IREDELL COUNTY HEALTH DEPARTMENT

(SEPTIC TANK) IMPROVEMENTS PERMIT AND CERTIFICATE OF COMPLETION
(Ground Absorption Sewage Disposal System -- G. S. Chapter 130-Article 13C)

LOCATION Compton Park off of Old Mountain Rd

Plot of System

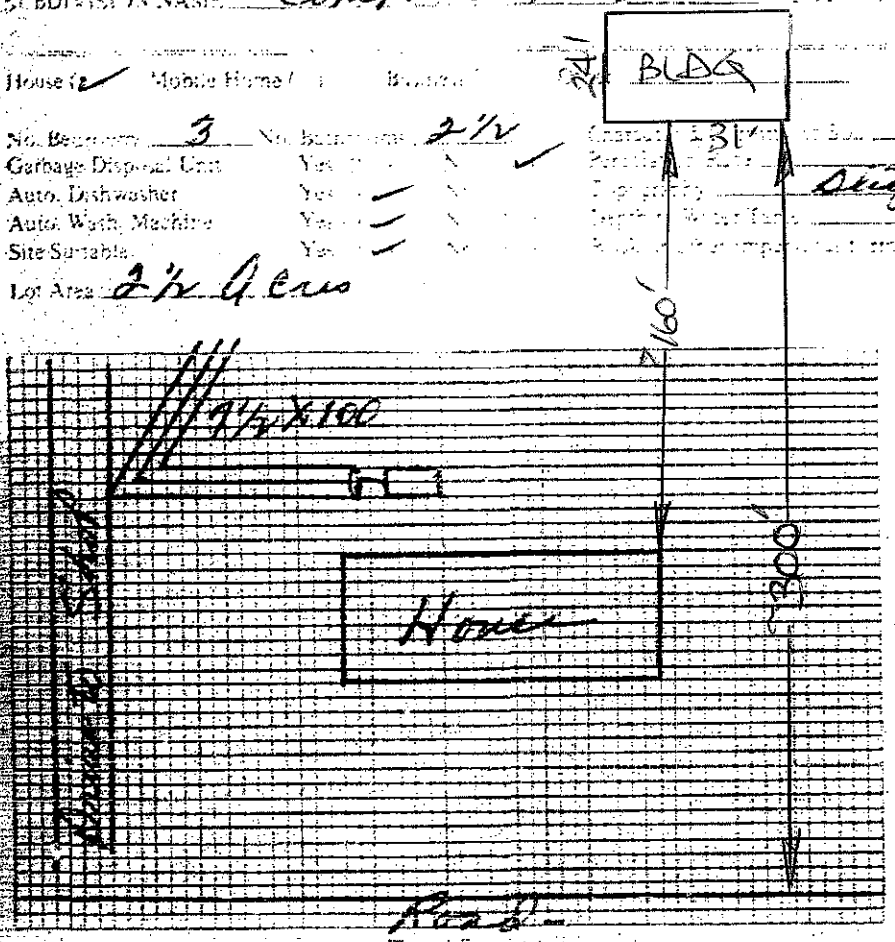
COMMENTS: Well field should be put over Tank Holes for Maintenance Purposes. Tank approx. 3' Deep due to Slope out Downslope and surface water should be diverted away from both Tank & Lines.

The proposed OUT BUILDING addition does not appear to impact the existing septic system.
**NOTE:
